Appendix B: Stakeholder Communication & Engagement  
Tulare Lake Subbasin GSAs

### Comment O-1

**FIGURE 1**

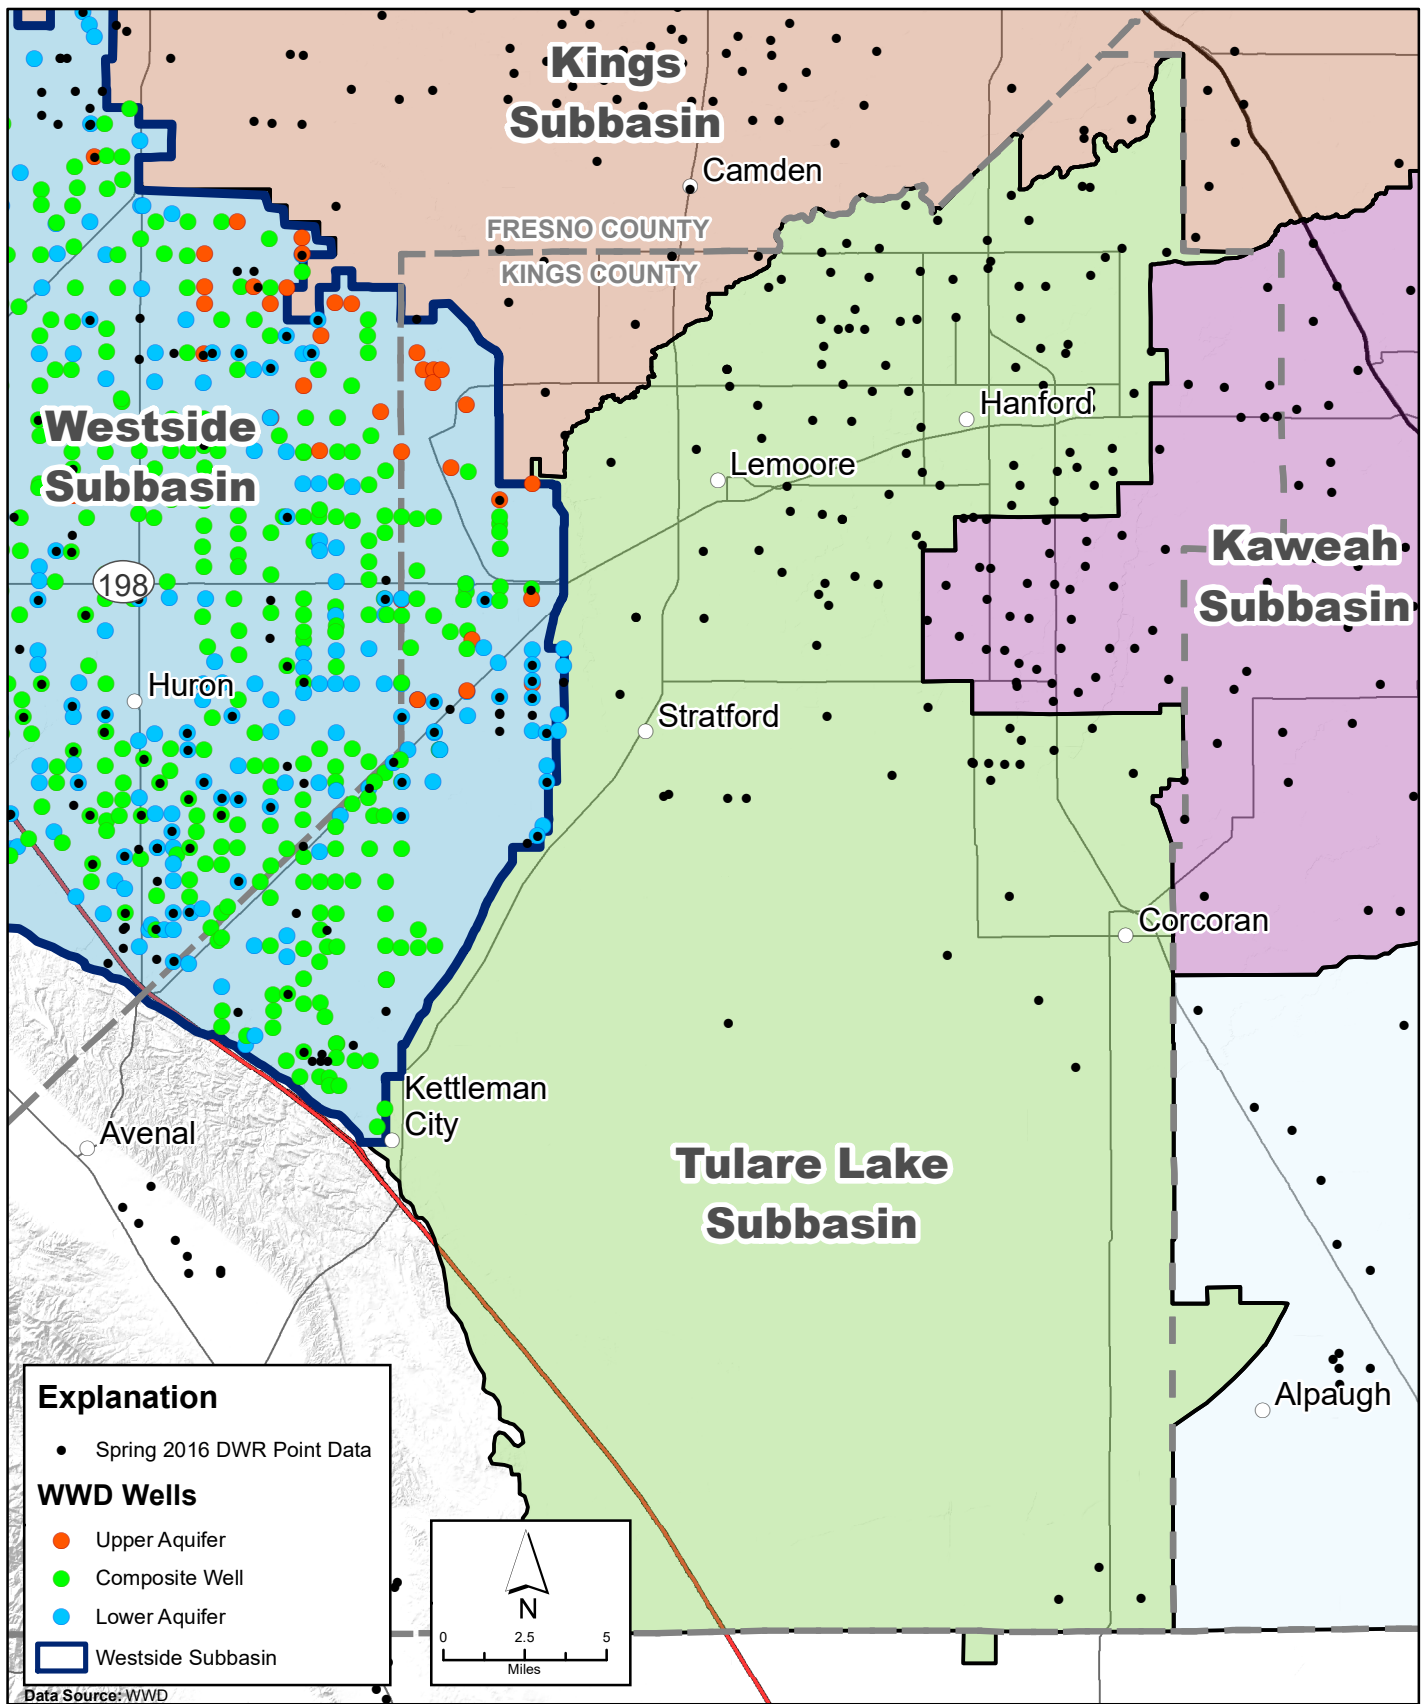
The spatial information for wells used to develop the DWR water level contours are readily available for 2016 (DWR, 2019). Review of these data reveals that the majority of wells used by DWR to develop contours of unconfined potentiometric head within the Westside Subbasin are screened in the Lower Aquifer (**WWD Attachment: Figure 1**). Given that groundwater level readings can vary considerably between the Upper Aquifer and Lower Aquifer, water levels from the Lower Aquifer are unlikely to be representative of unconfined water levels (even in the Spring) and should not be used to support the GSP conclusions of subsurface flow in the unconfined aquifer between the Westside and Tulare Lake Subbasins.

**FIGURE 2**  
**Arsenic Concentration in Groundwater Wells**  
**Most Recent Reported Value**

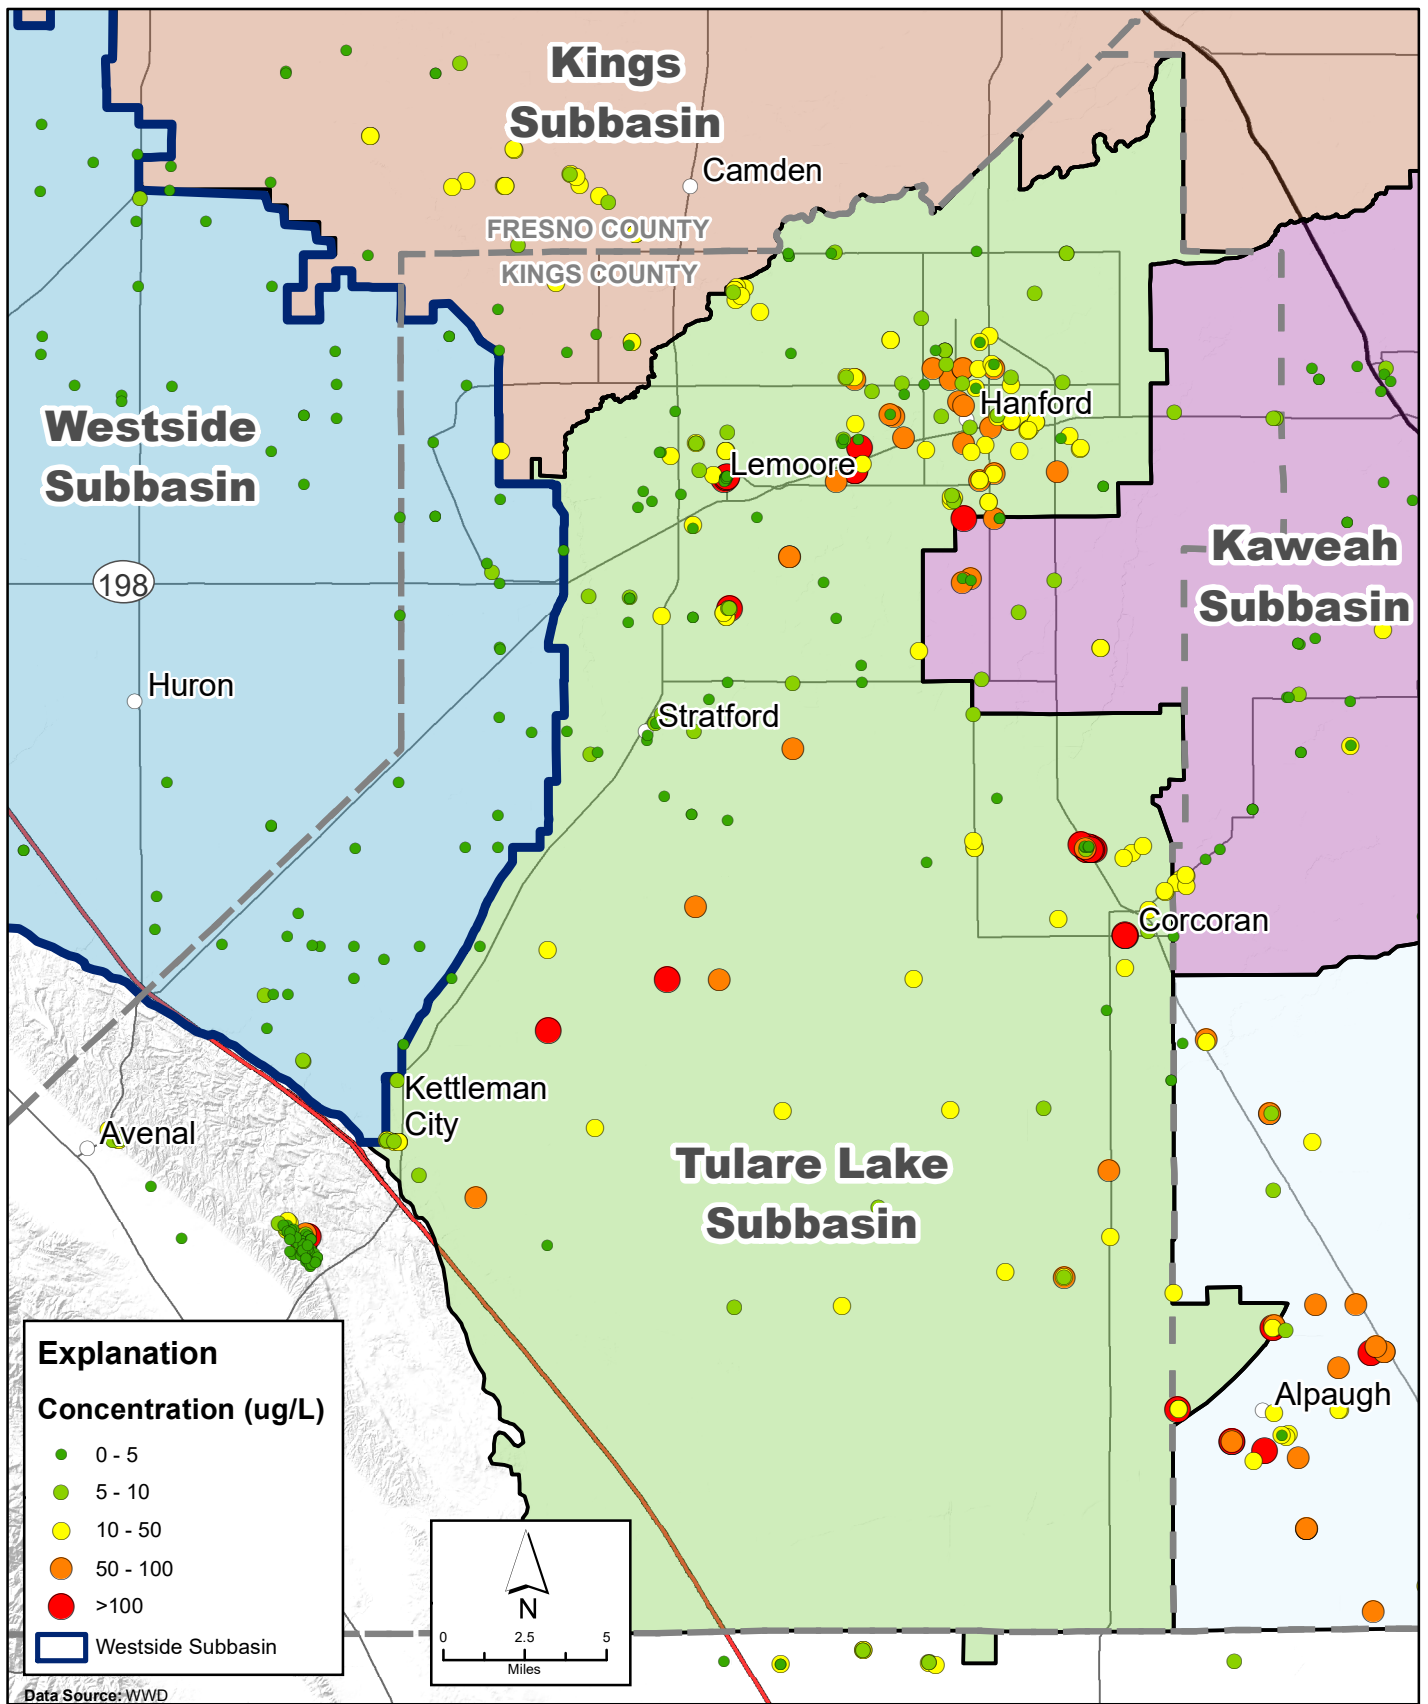
**Westlands Comments:** Both reports highlight how depth significantly influences TDS concentrations. However, Figure 3-30 does not report the depth of the wells or the aquifer the TDS sample represents which can substantially influence how data is interpreted. Furthermore, none of the maps shows the time period being represented. With respect to the concentration of arsenic in groundwater, neither the most recent nor the maximum arsenic concentration in the data available from GeoTracker is as high as those shown in Figure 3-31 (**WWD Attachment: Figure 2 and 3**). Furthermore, the density of wells with available arsenic data in the Geotracker GAMA database is substantially less than that shown in Figure 3-31.
